Project	<b>IEEE 802.16 Broadband Wireless Access Working Group</b> < <a href="http://ieee802.org/16">http://ieee802.org/16</a> >	
Title	<b>System Parameters for IEEE 802.16d</b>	
Date Submitted	<b>2004-03-11</b>	
Source(s)	Jaeho Jeon, Soonyoung Yoon, Seungjoo Maeng, Jiho Jang, Sijun Cho, Youngbin Chang	<a href="mailto:jhjeon@samsung.com">jhjeon@samsung.com</a> <a href="mailto:soon.young.yoon@samsung.com">soon.young.yoon@samsung.com</a> <a href="mailto:sjmaeng@samsung.com">sjmaeng@samsung.com</a> <a href="mailto:jiho.jang@samsung.com">jiho.jang@samsung.com</a> <a href="mailto:sijun.cho@samsung.com">sijun.cho@samsung.com</a> <a href="mailto:yb.chang@samsung.com">yb.chang@samsung.com</a>
	Samsung Electronics Co., Ltd. Dong Suwon P.O.Box 105 416, Maetan-3dong, Yeongtong-gu, Suwon-city, Gyeonggi-do, Korea 442-600	
Re:	Contribution supporting Sponsor ballot	
Abstract	System parameters to support public cellular operation and scalability

## System parameters for IEEE 802.16d

Figure 1 – Windowing on OFDMA symbols

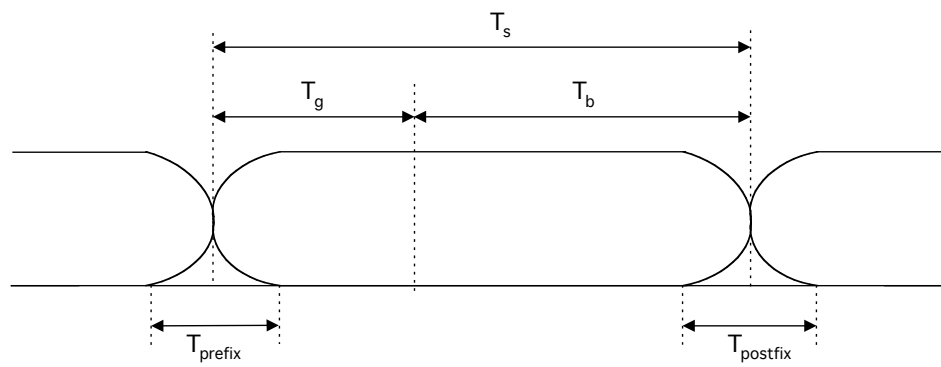
[Insert a following section ‘8.4.2.6 Basic system parameters’ and ‘8.4.2.7 Windowing’ after ‘8.4.2.5 Transmitted signal’]

Time window,  $w(n)$ , is used to reduce the out-of-band emission. The transmitting signal  $s(n)$  is represented as:

$$s(n) = w(n) * \sum_{k=-N_{used}/2, k \neq 0}^{N_{used}/2} b_k \exp((j2\pi k \Delta f)(n - N_g)) \quad n = -m, -m + 1, \dots, 0, \dots, N_s + m \quad (1)$$

where  $b_k$  is the frequency domain signal transmitted on the  $k$ -th subcarrier.  $N_g$  is the number of OFDM samples for  $T_g$ . Time window,  $w(n)$ , is represented as follows:

$$w(n) = \begin{cases} 0.5 \left( 1 + \cos \left\{ \pi \left( 1 + \frac{n+m}{2m} \right) \right\} \right) & -m \leq n \leq m \\ 1 & m < n \leq (N_s - m) \\ 0.5 \left( 1 + \cos \left\{ \pi \left( \frac{n - (N_s - m)}{2m} \right) \right\} \right) & (N_s - m) < n \leq (N_s + m) \end{cases} \quad (2.)$$

where  $N_s$  is the number of OFDM samples for  $T_s$ .  $(2 \cdot m)$  is the number of OFDM samples for  $T_{\text{prefix}}$  and  $T_{\text{postfix}}$ . Here,  $m$  is TBD.
